LAKESHORE PARK BUILDING JSP17-43

Consideration at the request of NSA Architects, Engineering, Planners for approval of Preliminary Site Plan and Stormwater Management Plan. The subject property is located in Section 3 west of Old Novi Road and south of South Lake Drive and is zoned R-4, One Family Residential. The applicant is proposing an update to Lakeshore Park in the City of Novi including an approximately 9,400 square foot community center, 129 parking spaces, one pavilion, and a bike lane to connect to the mountain biking trails.

MOTION SHEET

Sheet Number:
SPA A-101

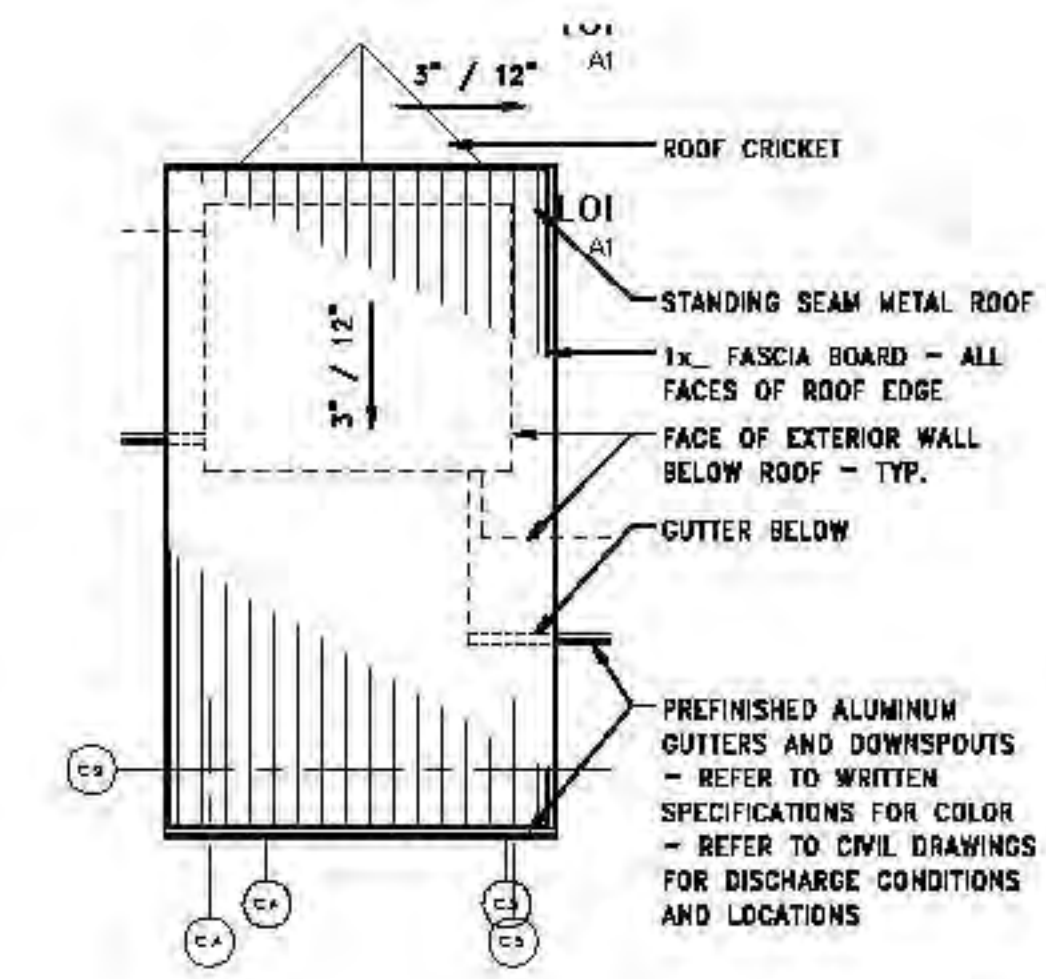
Response: The paved area under the canopy is an extension of the building patio and is NOT intended to function as a sidewalk. The path of egress is a direct exit from the Camp Room to the North or South and is perpendicular to the building. The spacing between the columns to either side of the aforementioned egress doors is a minimum of 16'-0". No door is obstructed by a column, nor is the path of egress. All dimensions of columns and their relationship to the building and exits are indicated on the Architectural Floor Plan on Sheet A-101.

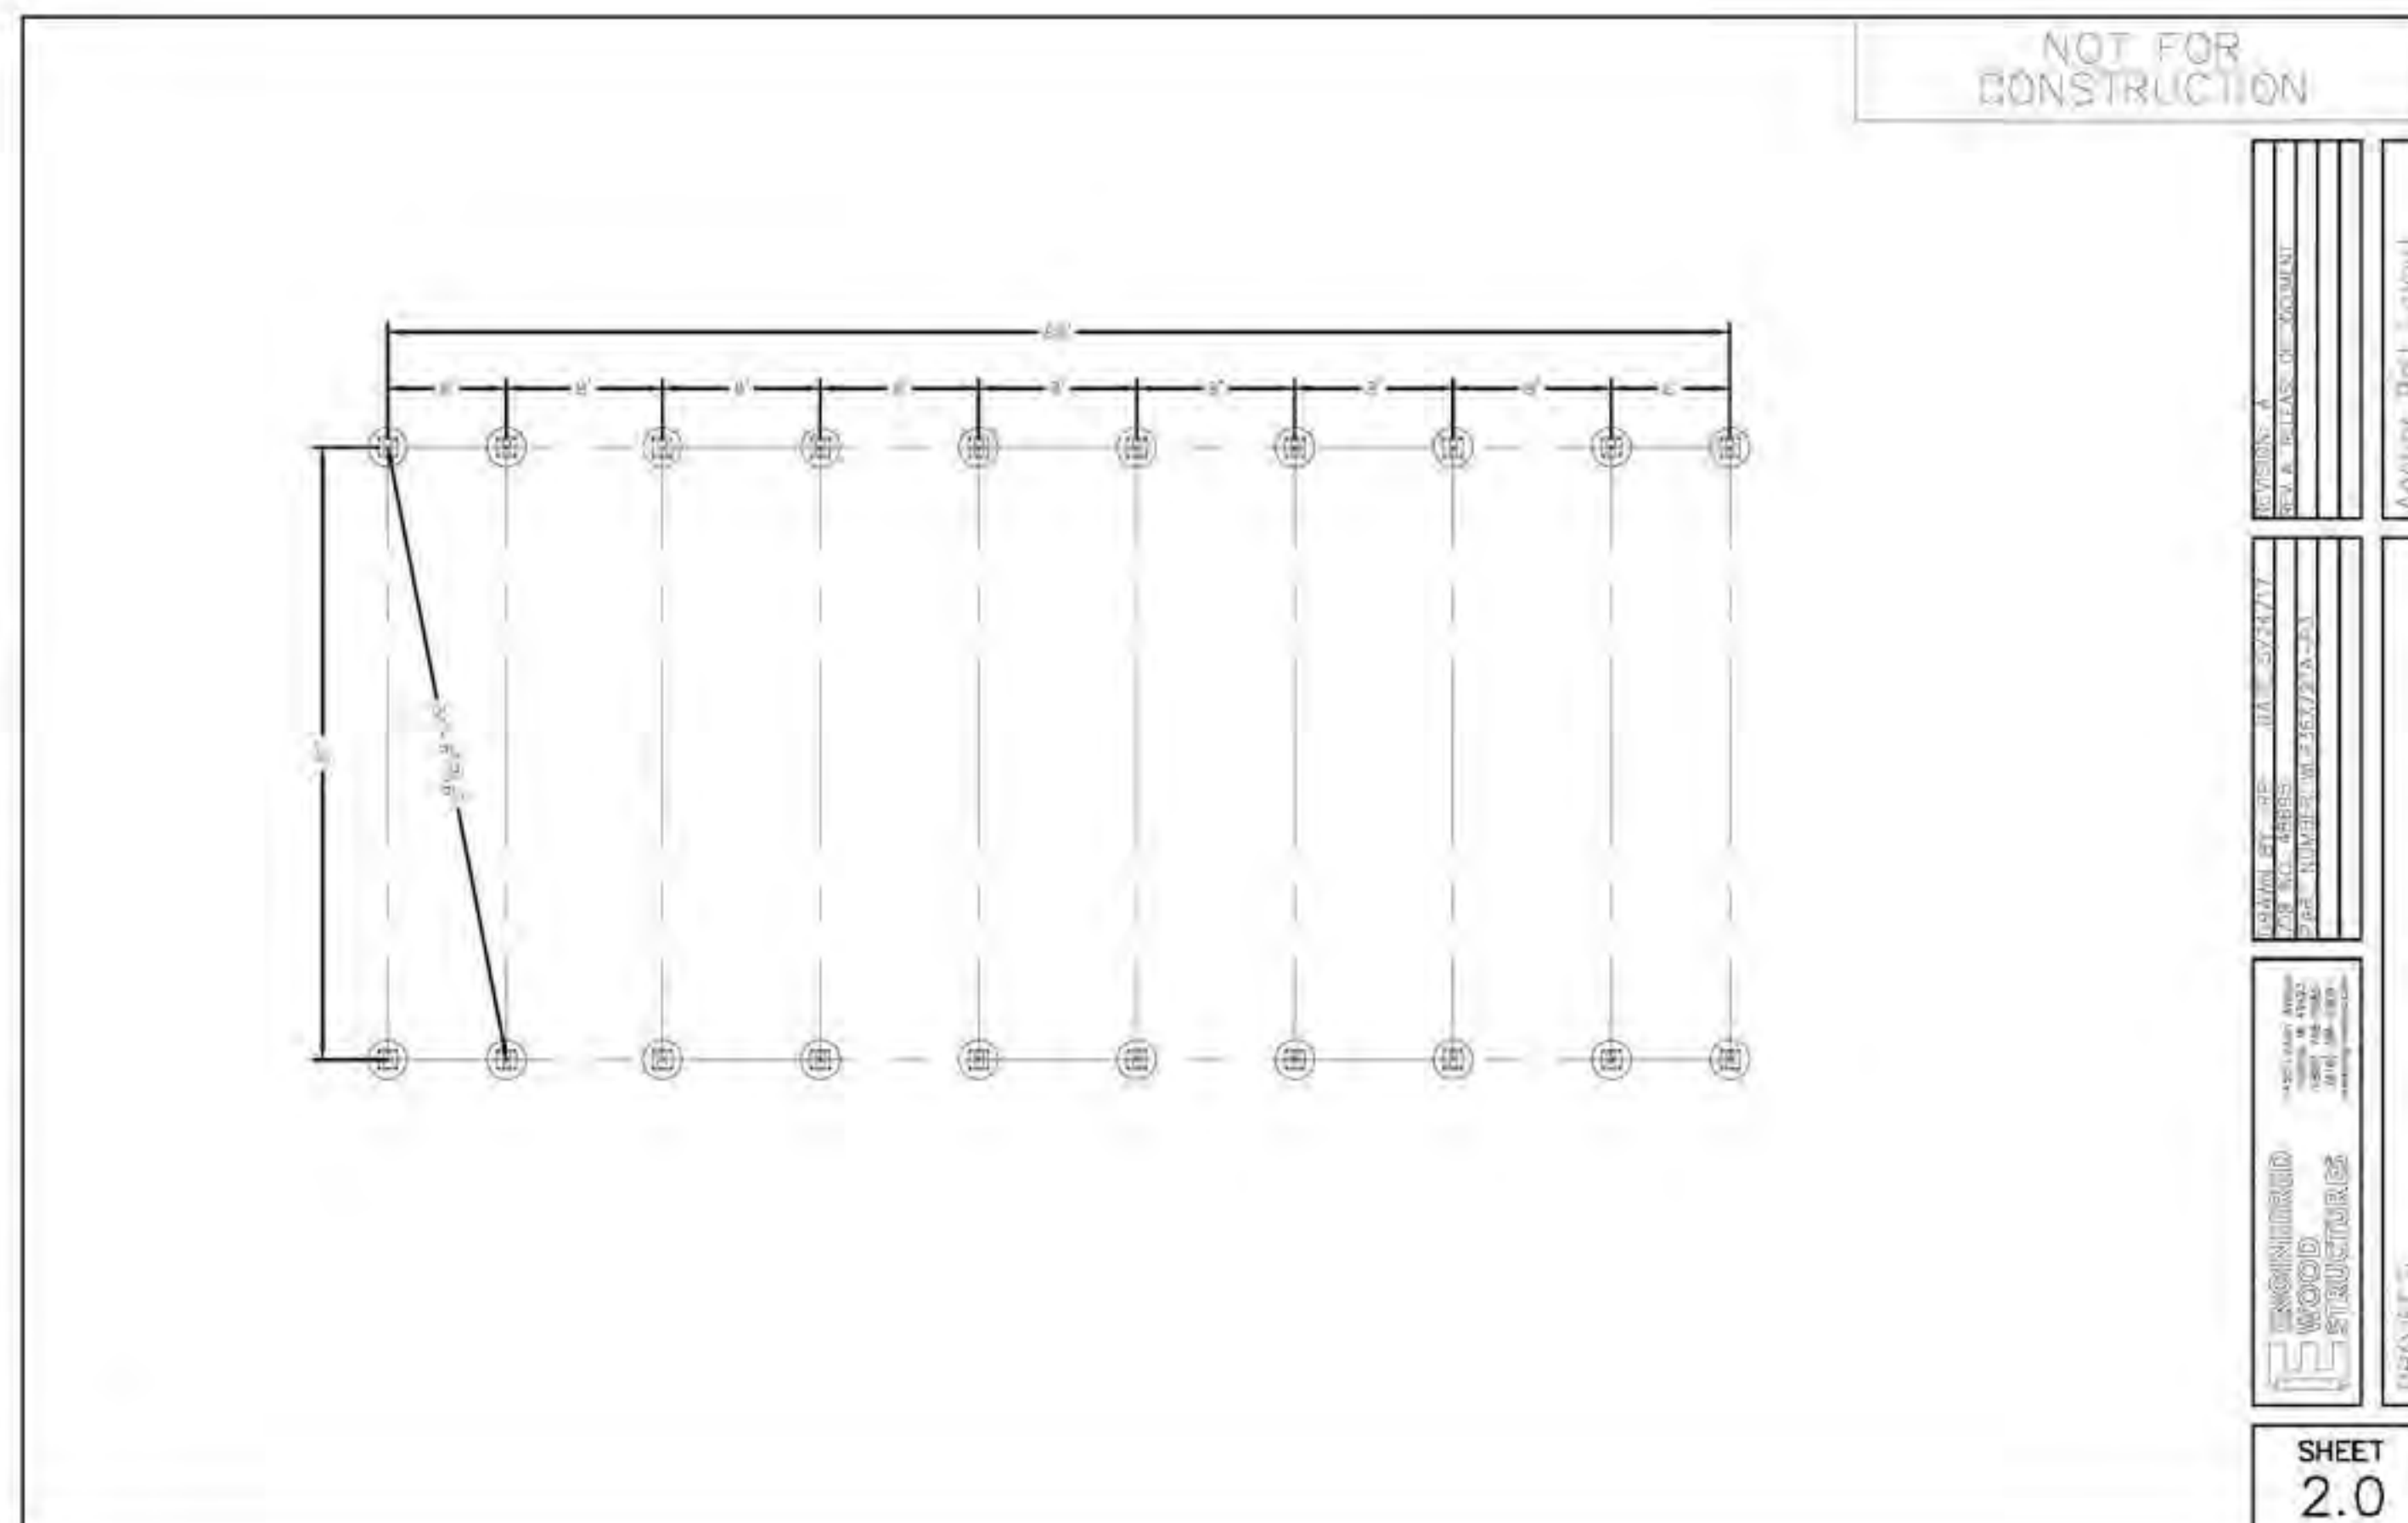
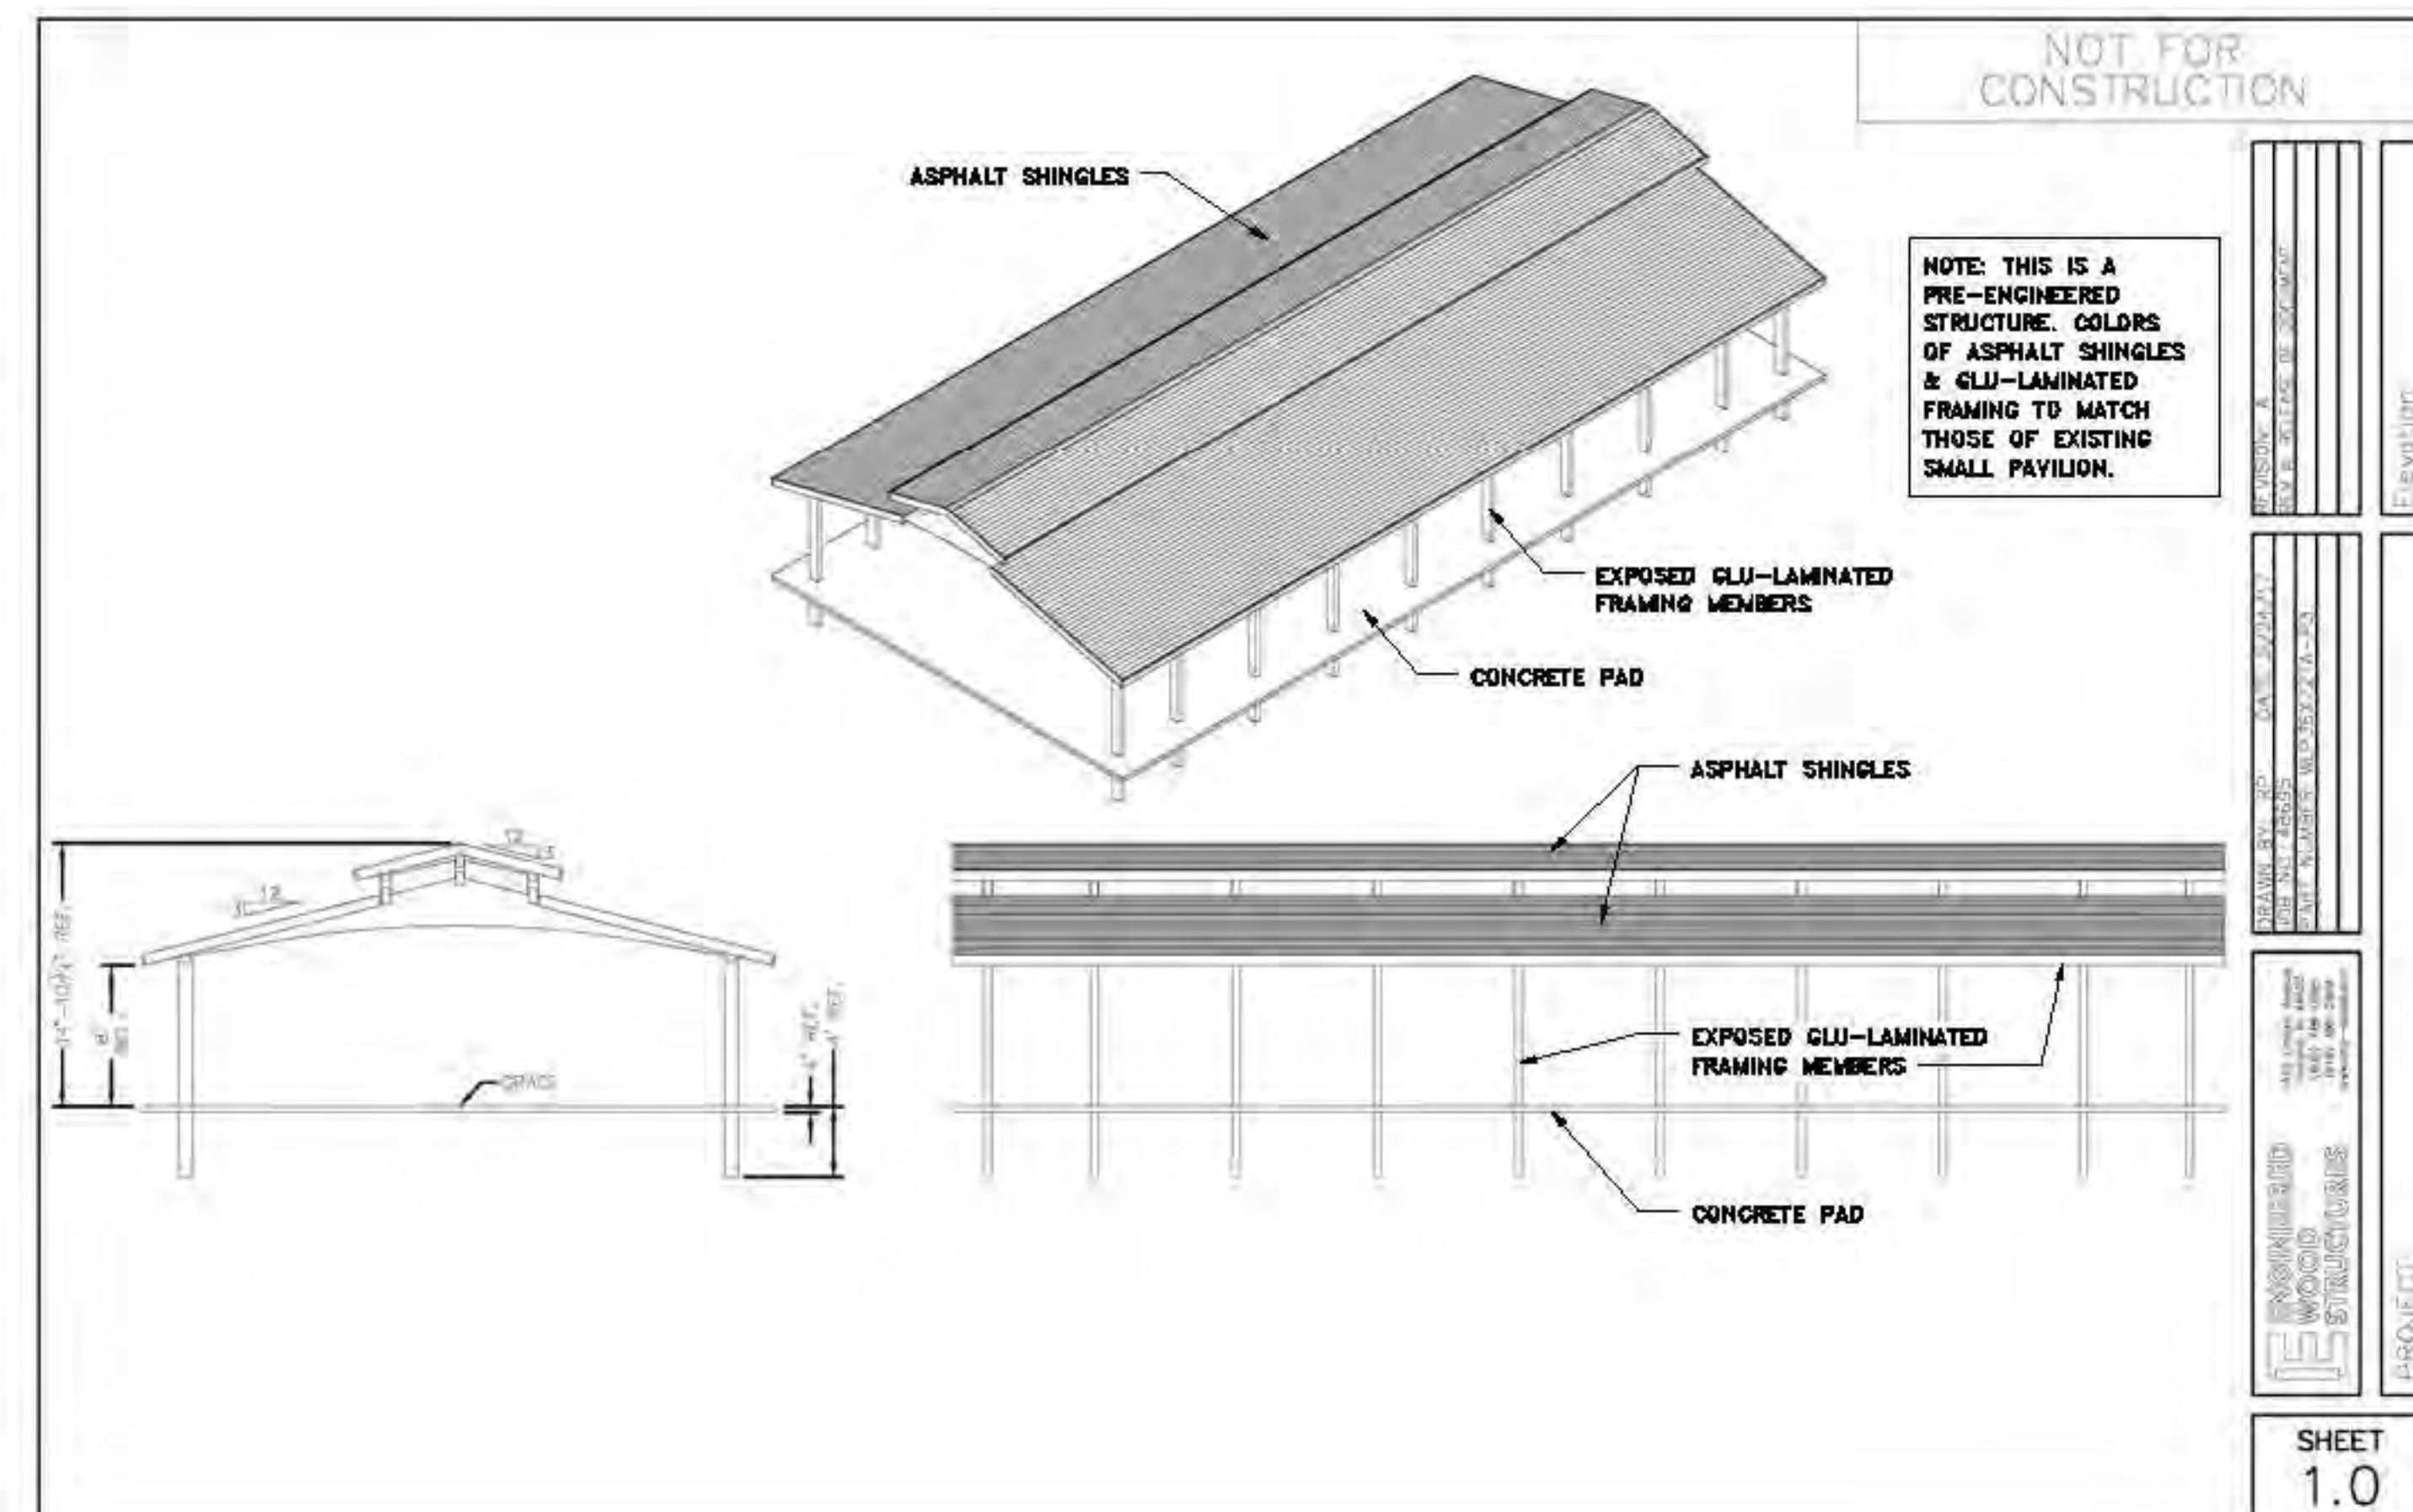
Response: A Section 9 Waiver was requested. A note requesting the waiver can be found on Sheet A-201.

Response: All mechanical equipment is contained within a fully enclosed roof well, surrounded on all sides by a minimum of 6 feet of vertical walls and buried within the center of the metal roof. This is indicated on both the Exterior Elevations (sheet A-201) and the Roof Plan (sheet A-121)
